# A14 Cambridge to Huntingdon Improvement Scheme

## POST CONSTRUCTION AUDIT - AUGUST 2020

PROJECT NUMBER: HA528983			DOCUMENT REF: HA528983-ACJV-HGN-SG_XX-RP-C-0003			
P01.1	First Issue	AKAK				
Revision	Purpose Description	Originated	Checked	Reviewed	Authorised	Date

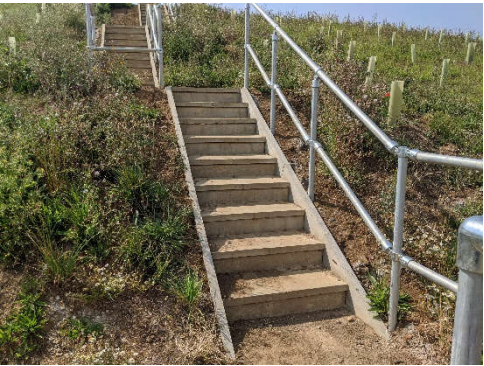
Ref.	Photo	Problem/Observation	Recommendation
S2.1		<p><u>Observation:</u> It was observed that there are two signal-controlled crossings of the circulatory carriageway, where NMU 2.2 routes via the Roundabout central island, with equestrians separated from pedestrians and cyclists at a parallel equestrian crossing.</p> <p>While it is noted that there is separate crossing provision for equestrians, DMRB states this should be a fenced, grassed holding area of 10.0 m wide by 5.0 m long.</p> <p>It is noted that no high friction surfacing is currently provided on the carriageway to prevent horses from slipping, although it is also noted that the crossings are not currently available for use.</p>	<p>It is recommended, as per DMRB, that the holding area for equestrians should be a fenced, grassed area of 10.0 m wide by 5.0 m long.</p> <p>It is recommended, as per DMRB, that a 10.0m band of high friction surfacing should be provided on the carriageway to prevent horses from slipping, and, where possible, this should be of the same colour as the carriageway.</p> <p>The British Horse Society (BHS) acknowledge that there may be circumstances where a variation from the standard design is appropriate.</p> <p><b>Designers Response:</b></p>

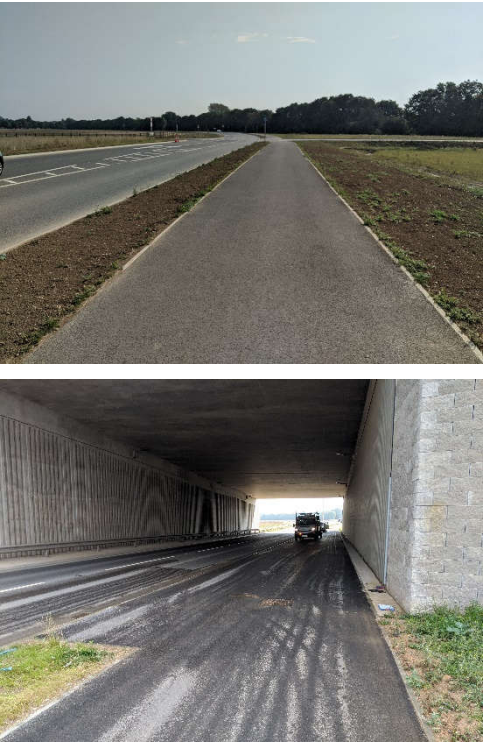
Ref.	Photo	Problem/Observation	Recommendation
S2.14		<p><u>Problem:</u> It is noted that signs to <i>TSRGD</i> Diagram 956.1 are located adjacent to NMU 2.4/2.5 indicating a route for use by pedal cycles, horses and pedestrians only.</p> <p>It is noted that tactile paving has not been provided at the junction shown in the photo.</p>	<p>It is recommended that appropriate tactile paving and markings (<i>TSRGD</i> Diagram 1023B, 1003B and 1009B) are provided.</p> <p><b>Designers Response:</b></p>
S2.15	-	<p><u>Observation:</u> It was noted in the 2016 Audit that steps were proposed to the west of Grafham Road Bridge connecting NMU 2.4/2.5 with NM 2.3. It is noted that these were not constructed as part of the final scheme.</p>	<p>It is recommended that confirmation is if steps were no longer deemed necessary.</p> <p><b>Designers Response:</b></p>
S2.16		<p><u>Observation:</u> On-site observations confirm that NMU 2.6 is 3.0 m wide, which concurs with the preferred minimum width for an unsegregated facility of 3.0 m as expressed in guidance, and a 1.8 m separation, in line with the preferred width in guidance.</p>	<p>No recommendation.</p> <p><b>Designers Response:</b></p>

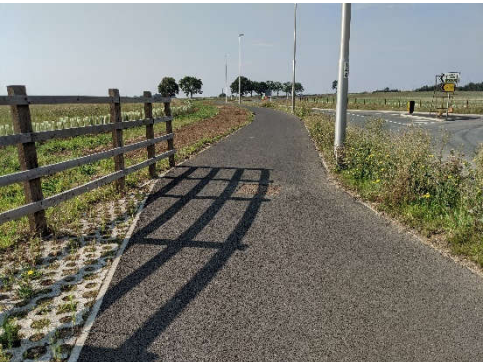
Ref.	Photo	Problem/Observation	Recommendation
S2.17		<p><u>Problem:</u> It is noted that tactile paving has not been provided at the junction shown in the photo.</p>	<p>It is recommended that appropriate tactile paving markings (TSRGD Diagram 1023B, 1003B and 1009B) are provided.</p> <p><b>Designers Response:</b></p>
S2.18		<p><u>Problem:</u> It is noted that a sign advising cycle users to rejoin the carriageway (Diagram 966) and a sign to <i>TSRGD</i> Diagram 956.1 on the reverse are provided as appropriate.</p> <p>However, the on-site audit identified that the transition between the route and the carriageway is still to be completed.</p>	<p>It is recommended that appropriate tactile paving and markings (TSRGD Diagram 1023B, 1003B and 1009B) are provided at the transition.</p> <p>This will likely include the need to warn pedestrians with visual impairments using tactile paving i.e. so they do not continue into oncoming traffic.</p> <p><b>Designers Response:</b></p>

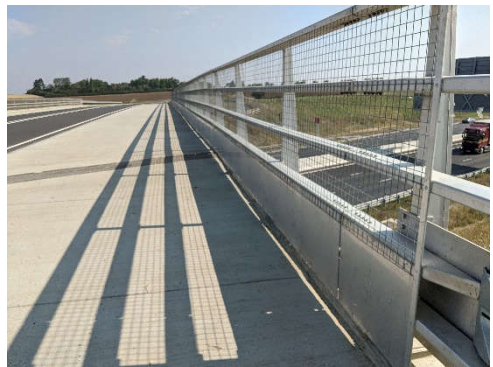
Ref.	Photo	Problem/Observation	Recommendation
S2.25		<p><u>Observation:</u> It is noted that signs to <i>TSRGD</i> Diagram 956.1 are located adjacent to NMU 2.7 indicating a route for use by pedal cycles, horses and pedestrians only.</p> <p>It is noted that tactile paving has been provided at the junction shown in the photo (access to/from emergency/maintenance access from A14).</p> <p>The route extends to connect with existing facilities to Buckden and The Offords.</p>	<p>It is recommended that appropriate markings (<i>TSRGD</i> Diagram 1023B, 1003B and 1009B) are provided.</p> <p><b>Designers Response:</b></p>
S2.26	-	<p><u>Observation:</u> As observed during the 2016 Audit, users are required to negotiate tight angles i.e. circa 90 degrees, at various locations.</p>	<p>It is recommended that all 90-degree angles should be refined to include a 45-degree splay (or suitable radius) to ease movement and avoid conflicts between users.</p> <p><b>Designers Response:</b></p>

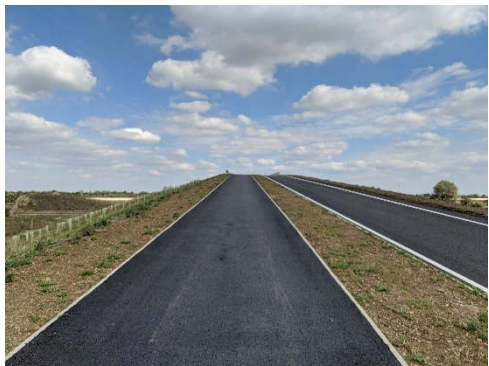
Ref.	Photos	Problem/Observation	Recommendation
S3.27		<p><u>Observation:</u> It is noted that the route connects with a bridleway (to Conington) that continues east of Conington Road at the same location that NMU 4.4 rejoins the carriageway.</p> <p>Appropriate signage is provided.</p>	<p>No recommendation.</p> <p><b>Designers Response:</b></p>

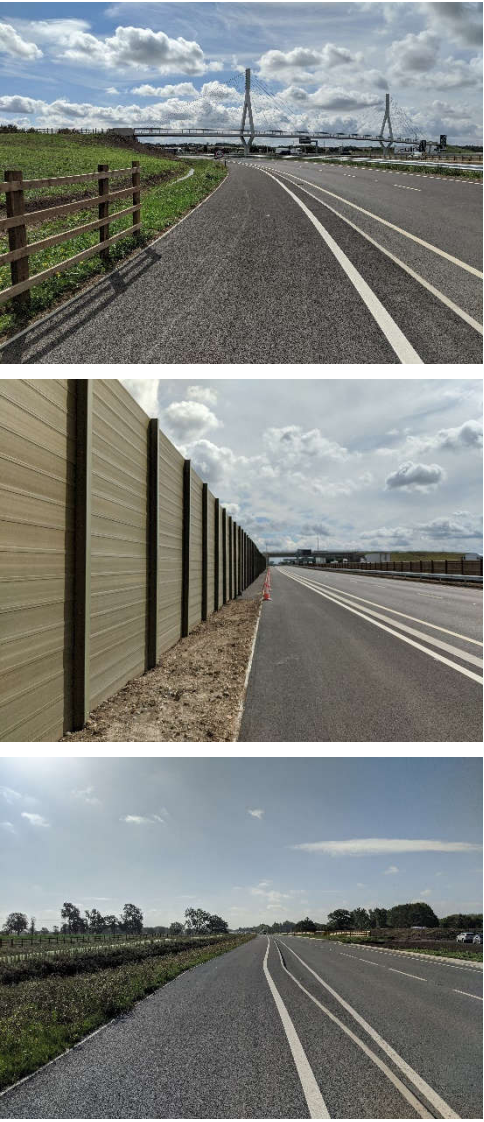
Ref.	Photos	Problem/Observation	Recommendation
S4.1		<p><u>Problem:</u> It is noted that no dropped kerb is provided where the off-road route (NMU 5.1) begins/terminates on the de-trunked A14, east of New Barns Lane Bridge and west of the Swavesey Junction. It is noted that the termination of the off-road route presents a barrier for some users i.e. those uncomfortable with cycling on-road.</p> <p>It is important to ensure that the transition provided is safe, comfortable to use and minimises delay to cyclists.</p> <p>It was understood that this route was to extend along the existing A14, Huntingdon Road from Fenstanton to the Swavesey Junction. However, on site observations show that the route terminates between New Barns Lane Bridge and the Swavesey Junction.</p>	<p>It is recommended that a dropped kerb is provided to enable users to transition from the road.</p> <p>It is recommended that appropriate tactile paving and markings (TSRGD Diagram 1023B, 1003B and 1009B) are provided at the appropriate transitions. This will likely include the need to warn pedestrians with visual impairments using tactile paving i.e. so they do not continue into oncoming traffic.</p> <p>It is recommended that signs advising cycle users to rejoin the carriageway (Diagram 966) are provided as appropriate, with signs to <i>TSRGD</i> Diagram 956.1 provided to advise cyclists transitioning from the carriageway.</p> <p>The 2016 Audit recommended opportunities to link NMU 5.1 with: Regional Route 24; Footpath 86/3; and Regional Route 24, via Fen Drayton, as well as providing a link between NMU 5.1 and NMU 4.7 i.e. via the provision of a suitable crossing facility across the existing A14. It is recommended that confirmation is provided as to the omission of these links, particularly the extension of the route to link with New Barns Lane Bridge.</p> <p><b>Designers Response:</b></p>

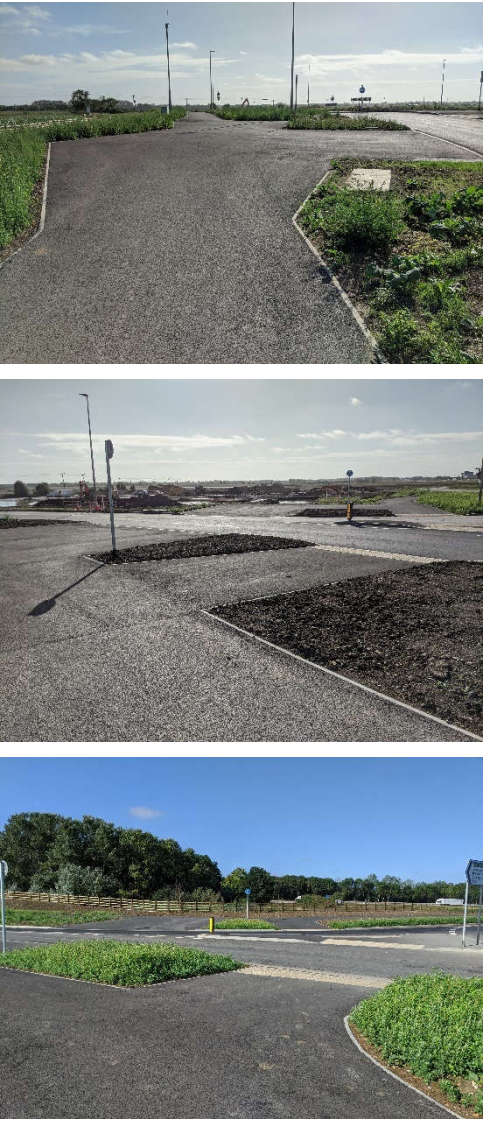
Ref.	Photos	Problem/Observation	Recommendation
S4.9		<p><u>Observation:</u> It is acknowledged that Swavesey NMU Bridge (NMU 5.3) is not to accommodate equestrians. As noted in the 2016 Audit, Bridleways 225/14 (just west of Swavesey Junction and 225/15 (see photo) are located north of the existing A14 and are linked by the NMU 5.1 and 5.2.</p>	<p>No recommendation.  <b>Designers Response:</b></p>
S4.10		<p><u>Observation:</u> It is noted that signs to TSRGD Diagram 956.1 are located adjacent to NMU 5.2 indicating a route for use by pedal cycles, horses and pedestrians only.</p>	<p>No recommendation.  <b>Designers Response:</b></p>

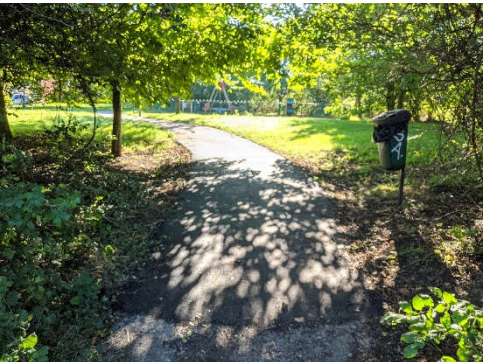
Ref.	Photos	Problem/Observation	Recommendation
S4.41		<p><u>Observation:</u> It is observed that tactile paving has been provided for users to cross between NMU 5.17 and the eastbound bus stop, and between the eastbound bus stop and NMU 5.14.</p> <p><u>Observation:</u> It is noted that the appropriate markings for pedestrian and cycle users has not been provided.</p>	<p>It is recommended that the dropped kerb upstands are checked and altered to be no more than the permissible 6 mm.</p> <p>It is recommended that the appropriate markings (TSRGD Diagram 1023B, 1003B and 1009B) are provided at the dropped kerb crossings intended for use by pedestrian and cycle users.</p> <p><b>Designers Response:</b></p>
